Access Compliance Report

Public Rights-of-Way

(Curb Ramps)

Intersection ID: 14183	Main Street: WEST_BV	Cross Street: OLD_STEELE_CREEK_RD	Location: NW
ADA ID: A6A8E5AD8256	Ramp Type: PerpDiag	Initial Pass/Fail: Fail	Overall Compliance: No
		Severity Score: 12.5

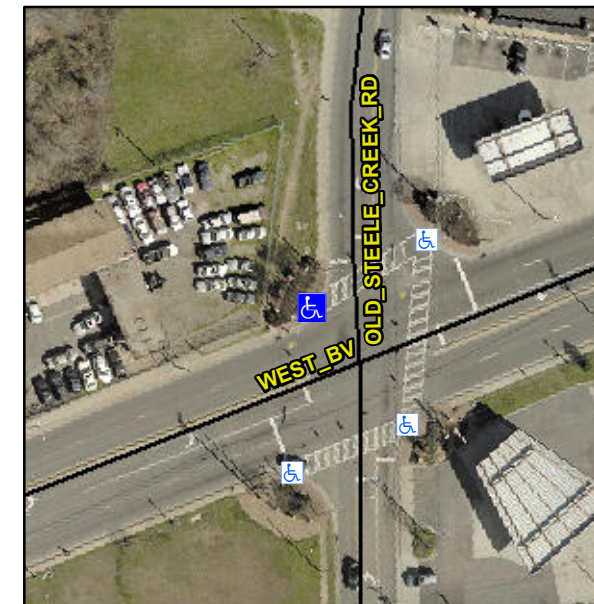
Not Found, R304.2.2

Compliance	Description	Data	Compliance	Description	Data
N/A	Ramp Length (in)	61.0	No	Ramp Slope (%)	9.1
Yes	Ramp Width (in)	48.0	Yes	Ramp XSlope (%)	1.9
N/A	Flare Type LT	N/A	N/A	Flare Type RT	N/A
N/A	Flare Slope LT (%)	N/A	N/A	Flare Slope RT (%)	N/A
N/A	Flare Traversable LT?	N/A	N/A	Flare Traversable RT?	N/A
N/A	Landing Length (in)	N/A	N/A	DWS Provided?	N/A
N/A	Landing Width (in)	N/A	N/A	DWS Contrast?	N/A
N/A	Landing Slope (%)	N/A	N/A	DWS Length (in)	N/A
N/A	Landing X Slope (%)	N/A	N/A	DWS Full Width?	N/A
N/A	Landing Curb? (Y/N)	N/A	N/A	DWS Offset (in)	N/A
N/A	Shared Landing?	N/A			
N/A	Gutter Ponding?	N/A	N/A	Gutter Slope (%)	N/A
N/A	Gutter Lip Ht (in)	N/A	N/A	Gutter X Slope (%)	N/A
N/A	Painted X Walk1?	No	N/A	Painted X Walk2?	Yes
	X Walk 1 Direction	To S		X Walk 2 Direction	To E
N/A	X Walk 1 Width (in)	N/A	N/A	X Walk 2 Width (in)	104.0
	X Walk 1 Slope (%)	5.4		X Walk 2 Slope (%)	1.1
	X Walk 1 X Slope (%)	1.6		X Walk 2 X Slope (%)	3.5

Remove & Replace Curb Ramp With Two New Directional Ramps or Equivalent.
